## HISTORIC AND DESIGN REVIEW COMMISSION

**HDRC CASE NO:** 2017-566  
**ADDRESS:** 402 CENTER ST  
406 CENTER ST  
139 N SWISS  
126 N CHERRY  
122 N CHERRY  
120 N CHERRY  
134 N SWISS  
130 N SWISS  
126 N SWISS

**OWNER:** K/T TX Holding, LLC  
**TYPE OF WORK:** Approval of a site plan for a twenty-four unit townhome development  
**APPLICATION RECEIVED:** October 24, 2017

## OHP-DRC Presentation (Case No. 2017-566)

Preliminary Site Plan

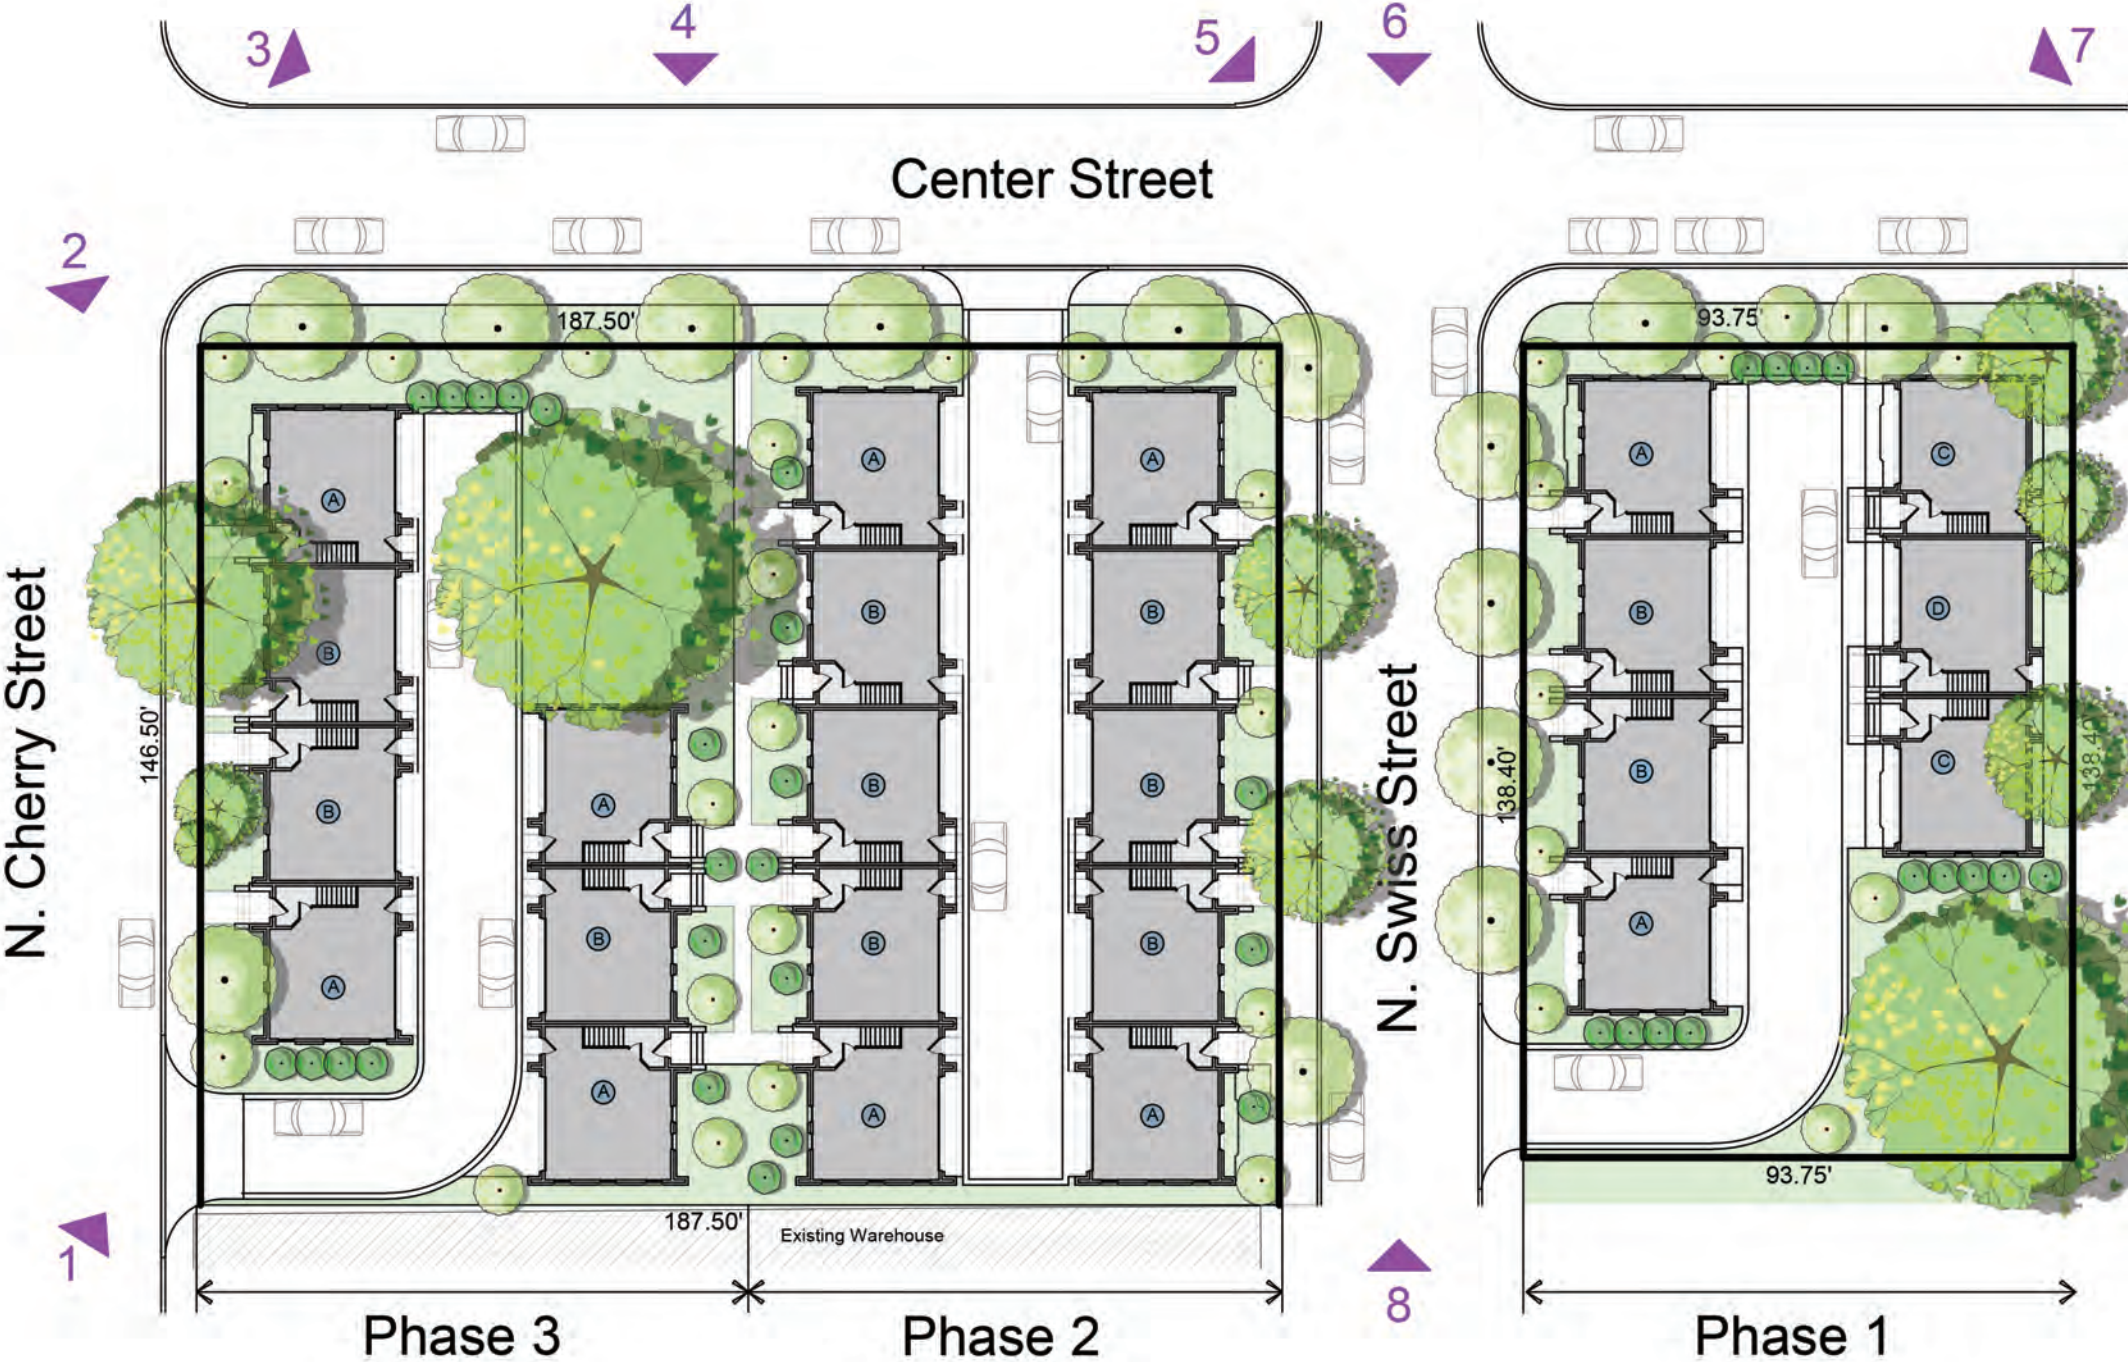
**COMMENTS/CONCERNS:** LE: OVERVIEW OF PAST UPDATES IN THE  
PROPOSAL. - [OVERVIEW INCLUDES PREVIOUS APPROVAL]. INTENT IS A  
BROWNSTONE TYPE DEVELOPMENT. LE: CONCERNS REGARDING UNITS  
HAVING A PRIMARY FRONT INTERNAL. LE: QUESTIONS REGARDING  
FACADE ORIENTATION / DESIGN - MG: UNITS ON CENTER STREET  
DESERVE STOOPS JUST AS THOSE ON N SWISS AND CHERRY.  
LE: SIDE STREET STOOPS ARE TURNING THEIR BACKS FROM THE  
STREET CORNERS. LE: QUESTIONS REGARDING SETBACK DEPTHS.

MG! STOODS SHOULD BE ORIENTED TOWARD CENTER. CONSIDER A WALL TO ENCLOSE VOIAS ON CENTER STREET, OR UNIT TO ENCLOSE OPENINGS.

CF! ELIMINATION OF GARAGES MIGHT PRESENT MORE SPACE AT CORNER FOR FENESTRATION / STOODS → FOR LIVE / WORK.

UG+CF! DISCUSSION ON OVERALL MODIFICATION OF SITE PLAN TO HAVE UNITS ADDRESS CENTER STREET.

## Preliminary Site Plan

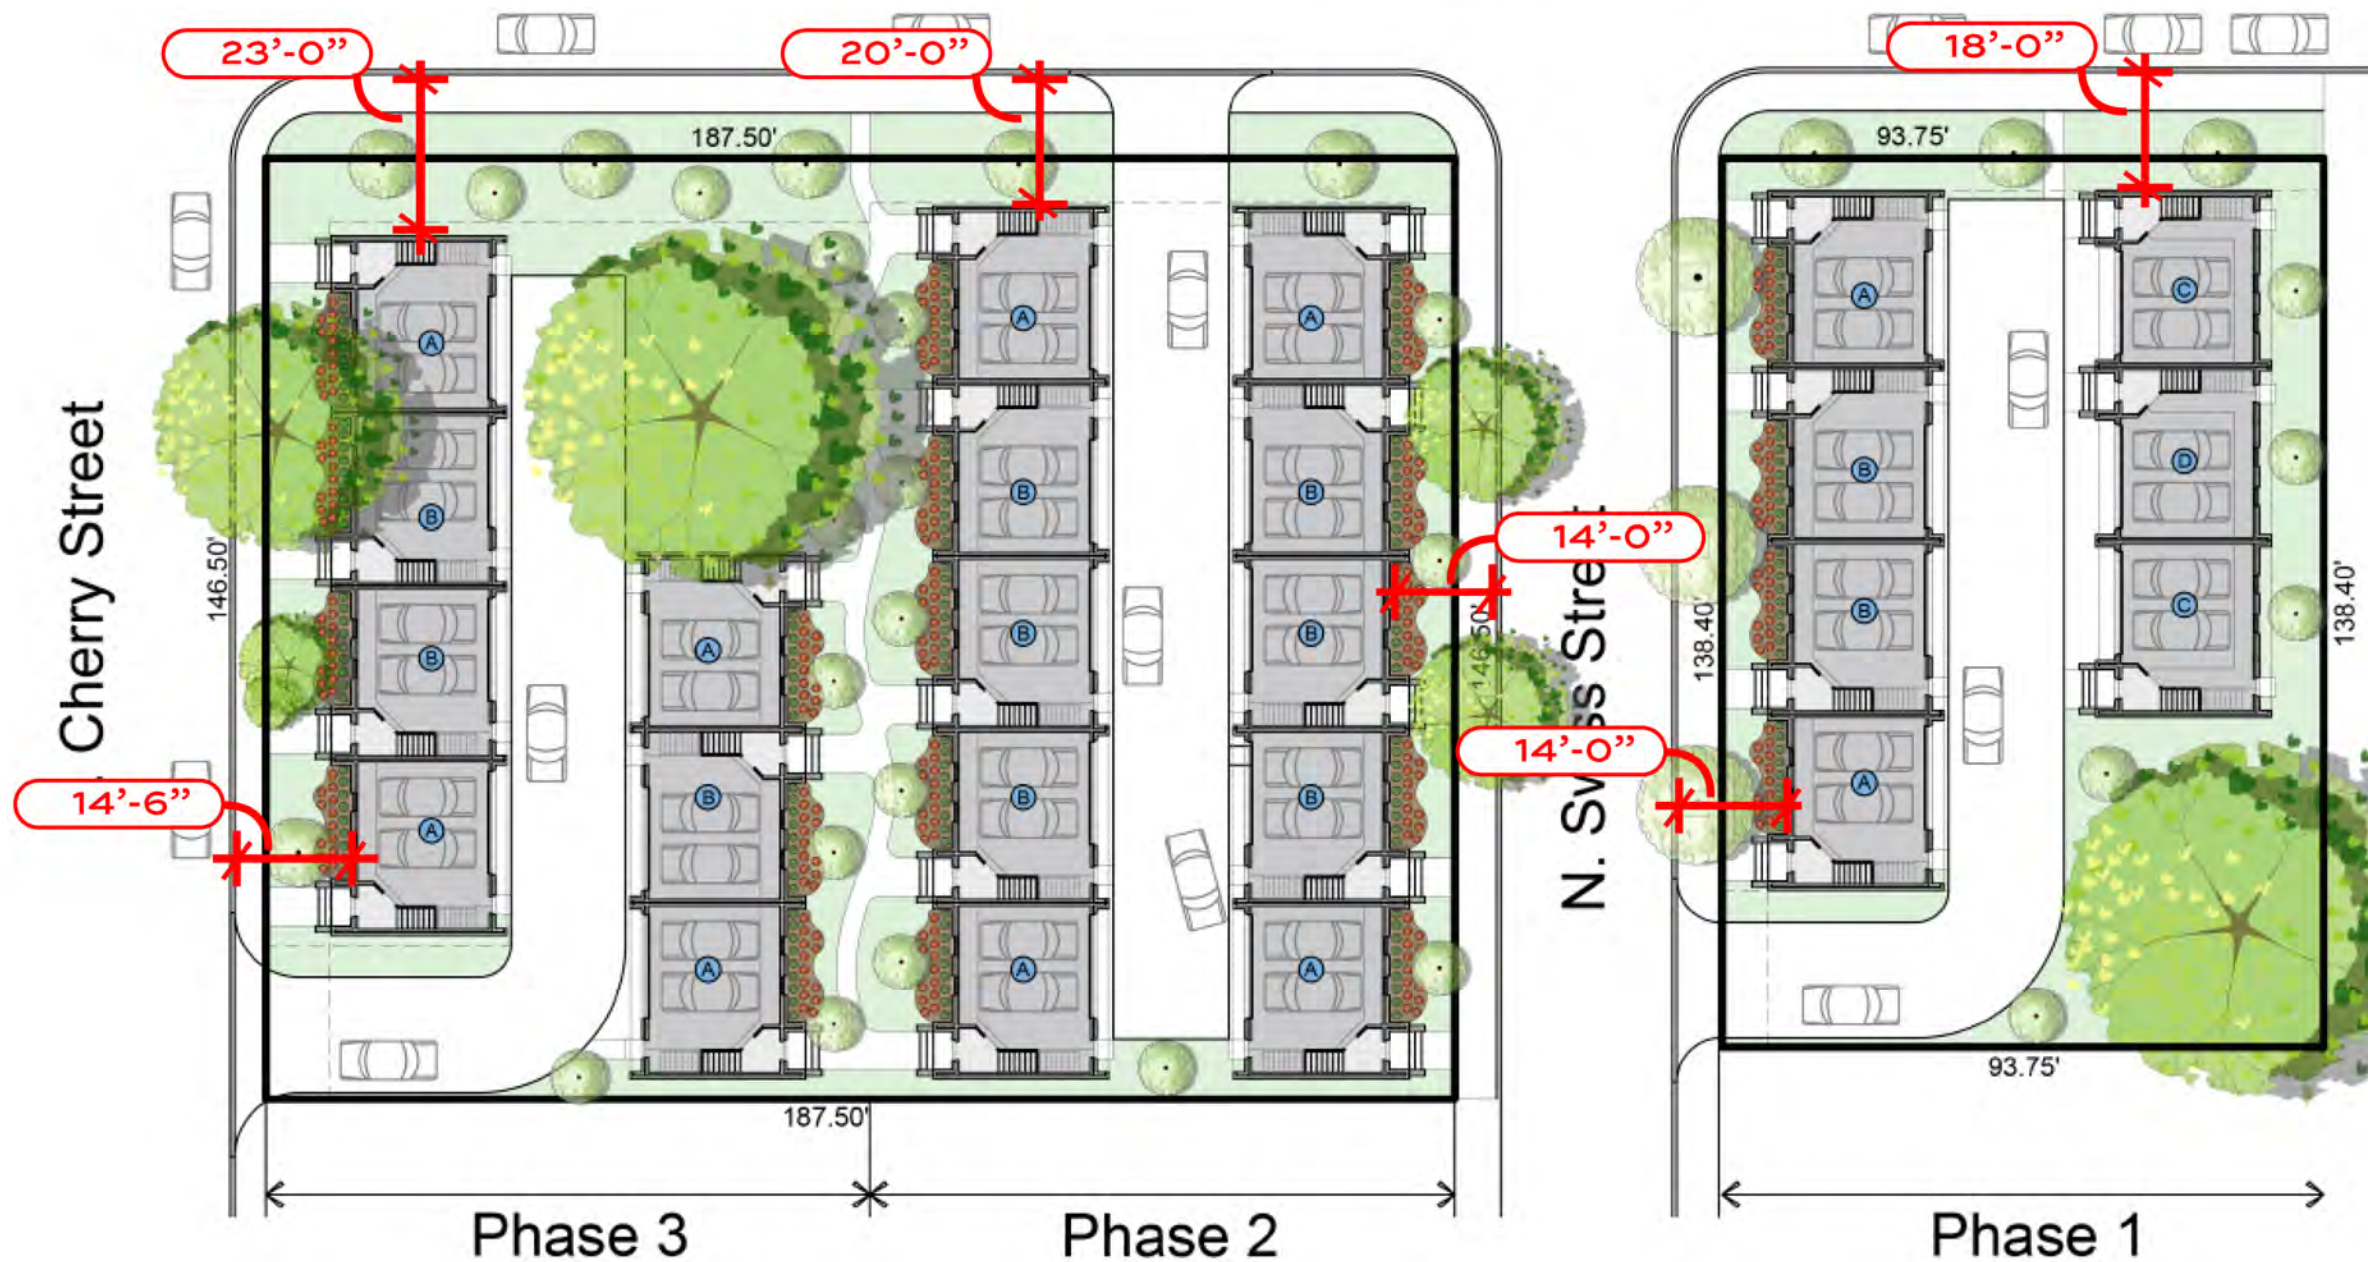
- i. That the applicant provide a diagram noting the relationship of proposed setbacks with those found historically in the adjacent blocks.
- ii. That the proposed new construction which fronts N Swiss feature a similar setback as that of the neighboring historic structure.

Terramark: Setbacks vary from 14'-0" to 20'-0" (Per Exhibit)

## Preliminary Site Plan

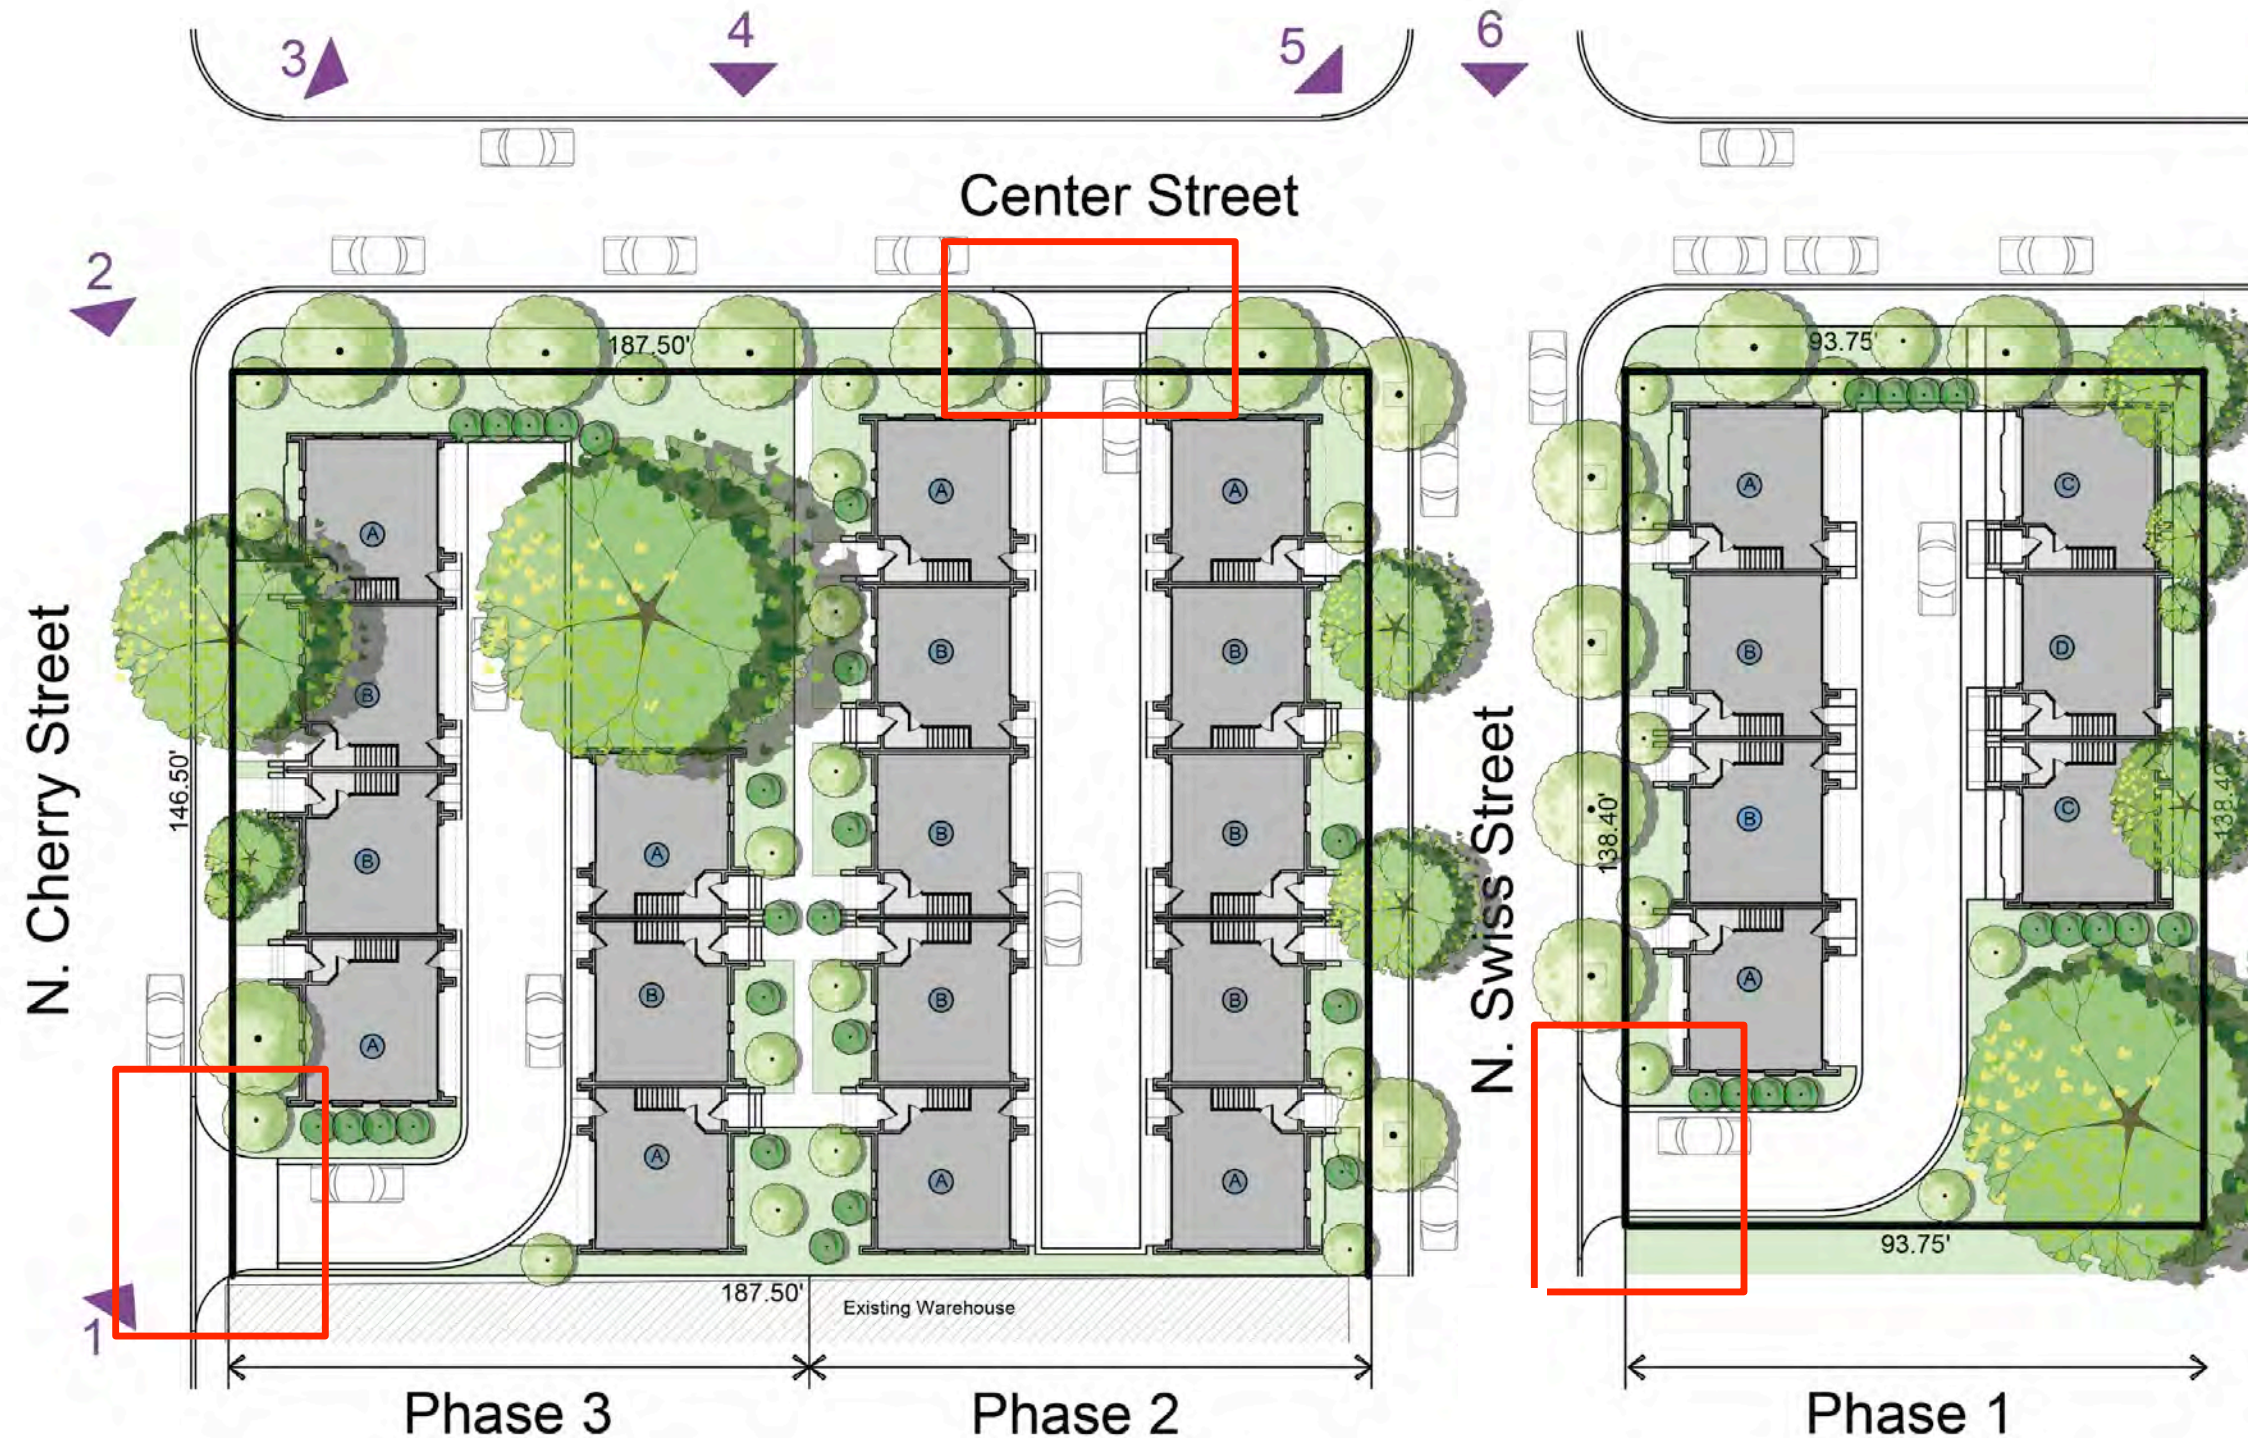
- iii. That units which feature a side elevation toward Center Street be reoriented to feature a primary orientation toward Center or be designed to provide architectural interest along Center.
- iv. That the fenestration pattern be developed to feature traditional solids to void ratios and avoid the placement of blank walls with exposure to the street.

- v. That the applicant explore alternative configurations that reduce the number of curb cuts / private driveways.
- vi. That the applicant provide information regarding the width, profile and materials of each driveway, apron and curb cut.

Terramark: Units with Side Elevations to Center St to be designed with architectural interest along Center.

Architecture elevations to be presented at Phase 1 HDRC Submission.

Terramark: Number of Curb Cuts/Private Driveways to be reduced , 3 New vs. 6 Existing
